ADDENDUM

Project: <u>Taylorsville 12,25</u>	Project No.: 5141710-19020101	Addendum No.: <u>1</u>
Project Address: 4505 South Brians Way, Taylorsville, Utah		Date: <u>15 May 2019</u>
Owner: Corporation of the Presiding Bishop of The Church of Jesus Christ of Latter-day Saints, a Utah corporation sole		
From (Architect): Bradley Gygi Architect & Associates, PLLC

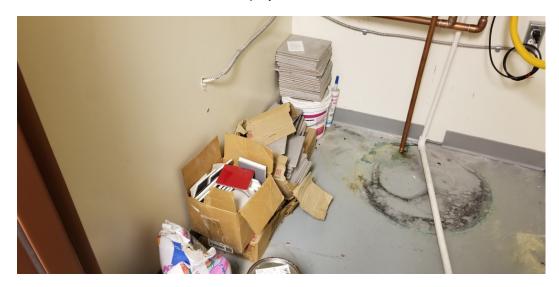
Item D.1. 09 3013 Ceramic Tiling: Contractor may use existing stock tile materials located in the mechanical room adjacent to the restrooms. See photograph below. There may not be enough Arctic White tile for all wall patching, but there appears to be adequate accent wall tile, floor tile and base for this project.
